Company	Trenz Electronic GmbH
PCN Number	PCN-20261019
Title	TEI0005-02 to TEI0005-03 Hardware Revision Change
Subject	Hardware Revision Change
Issue Date	2026-10-20

#10 Removed chamfer on PCB edge and added orientation mark.

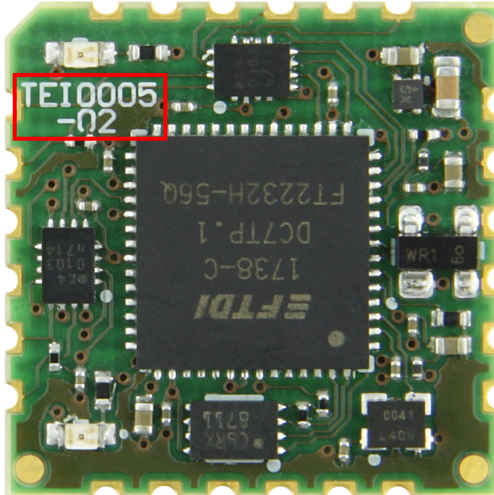
Type: PCB Change

Reason: Improve manufacturing process.
